# Crunch Fitness Signage (VAR26-009)

PRESENTED TO CITY COUNCIL– 5.18.26

# VAR – 1551 GREENRIDGE DRIVE

Resolution for variances to signage related to a pylon sign where none is allowed, and minimum ground clearance for the sign cabinet.

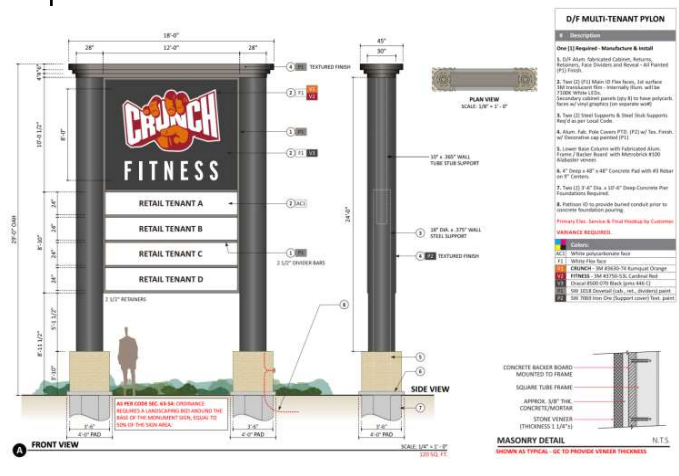
- (a) Location
- (2) Requesting Pylon sign located outside of the North Wilshire Sign Corridor.
- (c) Height
- Requesting pylon sign with a sign cabinet that does not meet the minimum 10' ground clearance.

- New pylon signs are not allowed in the requested area. Existing pylons signs (see images below) were permitted prior to the 2015 sign code amendment.
- Variance will reduce ground clearance by 12.5 inches, but will still provide pedestrian and low-profile vehicle clearance.

D/F MULTI-TENANT PYLON	
Description	
<b>One (1) Required - Manufacture &amp; Install</b>	
1. D/F Alu. Fabricated Cabinet, Returns, Retainers, Face Dividers and Reveal - All Painted (F1) Finish.

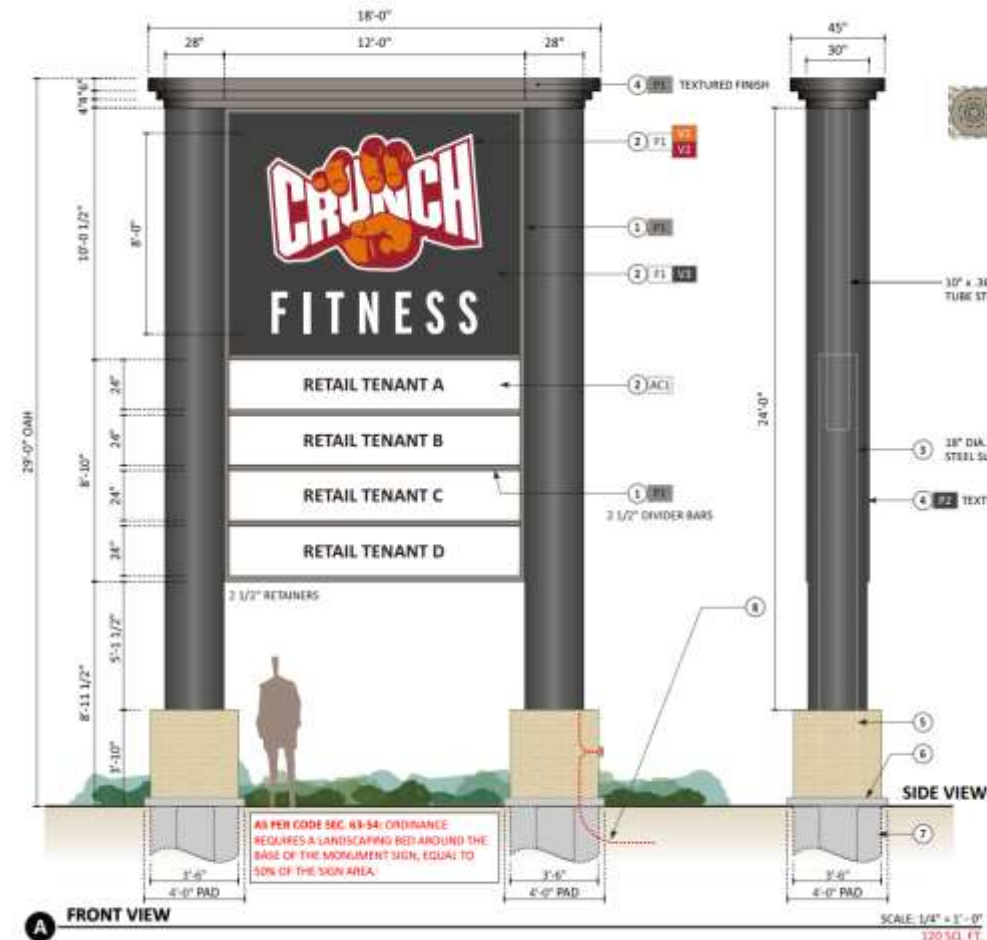
- Staff recommends denial of the variances as requested by the applicant.
- The site has direct frontage along Greenridge Drive and allows placement of a monument sign.
